RE: **Jomar/Martinez Residence**
2123 Candelaria NW
Grading Plan Stamp Date: 8/23/18
Hydrology File: G13D035

RE: **Jomar/Martinez Residence**
2123 Candelaria NW
Grading Plan Stamp Date: 8/1/18
Hydrology File: G13D035

Based on the submittal received 8/1/18, the Grading Plan cannot be approved for Plat or Grading Permit until the following are corrected:

ENGINEER'S SEAL	2123 CANDELARIA RD JOMAR CANDELARIA RESIDENCE	DRAWN BY DEM
	GRADING AND DRAINAGE PLAN	DATE 7-31-18
8/23/18 8/1/18	 1608 CENTRAL AVENUE SE SUITE 201 ALBUQUERQUE, NM 87106 (505) 972-0899	JAMAR CANDELARIA G&D
DAVID SOULE P.E. #14522		SHEET # C1
		JOB #

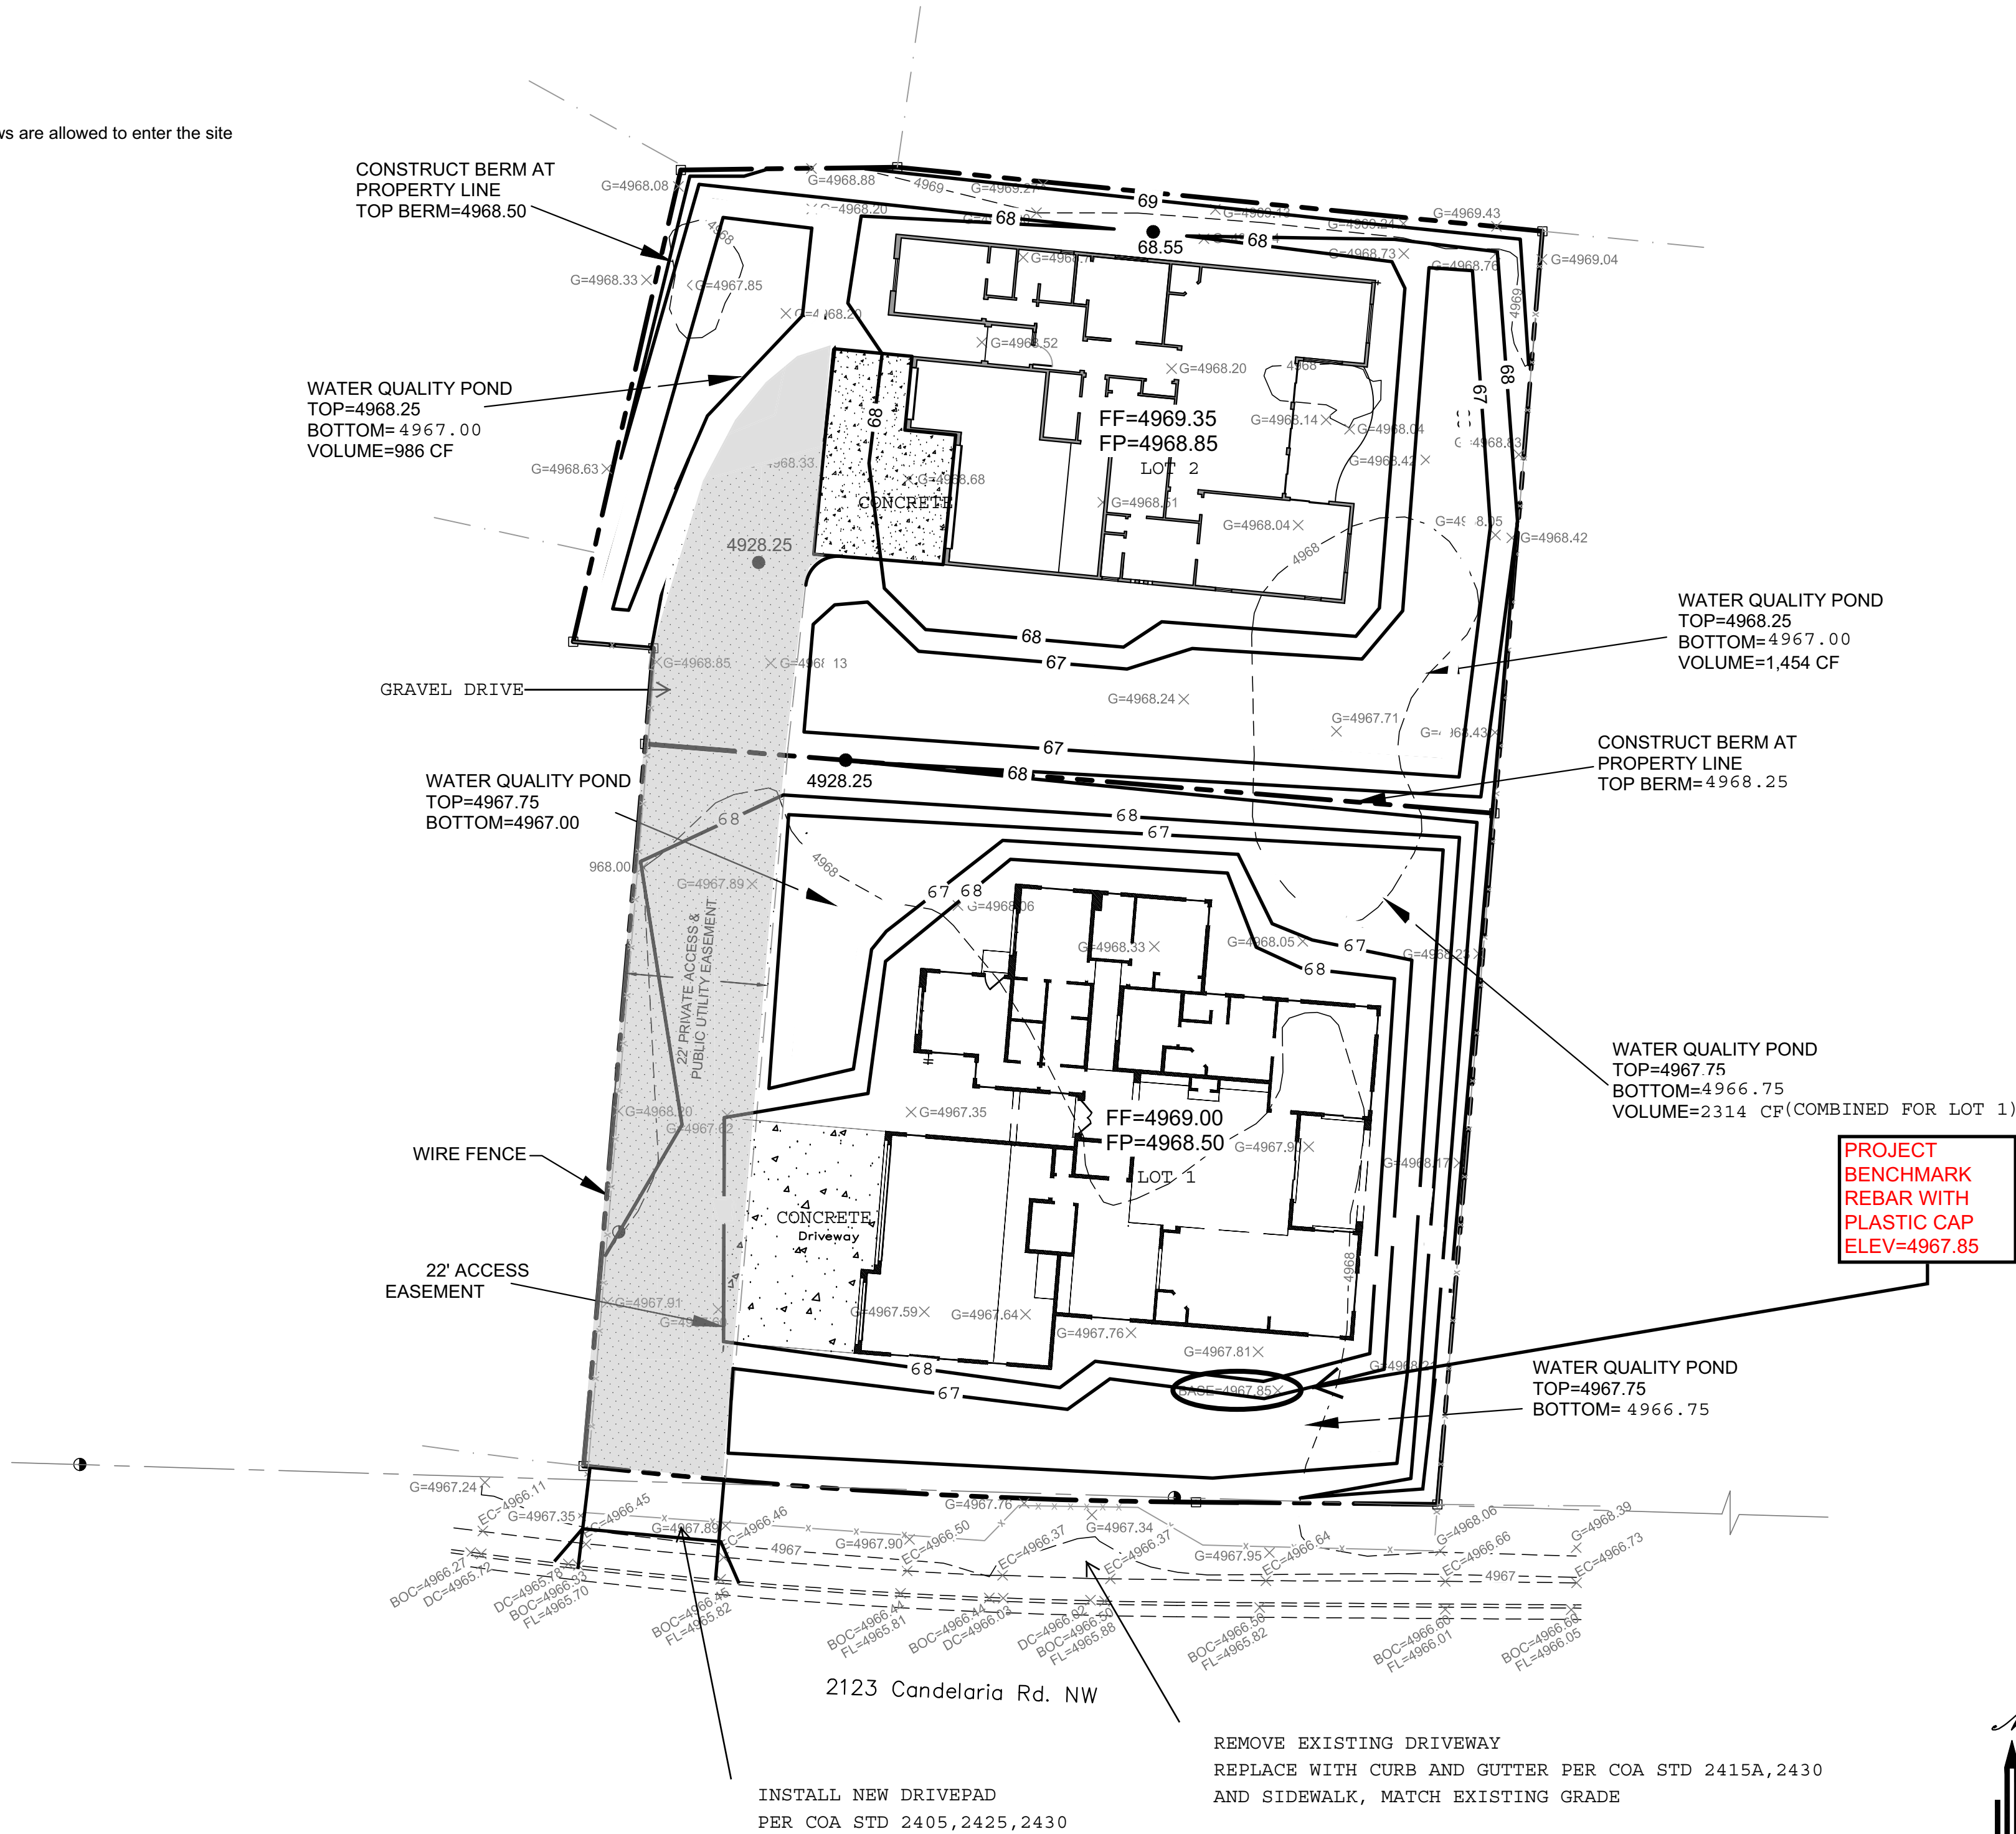
1. Include project benchmark. **ADDED**

2. Provide topographic survey for the adjoining properties (~10' across the property line); ensure your proposed grades tie in at the property line. **SURVEYOR COULD NOT ACCESS ADJOINING LOTS, WE HAVE PROVIDED GIS LIDAR TO SHOW AREA IS FLAT**

3. Add note on the plan that "No work shall be performed in the public ROW without an approved Work Order or Excavation Permit."

4. On the Plat, provide a drainage easement over the ponds and annotate using the [Plat Drainage Easement Note](#). This note replaces the need for a separate drainage covenant.

ADDED NOTE #4

PLAT WILL INCLUDE LANGUAGE
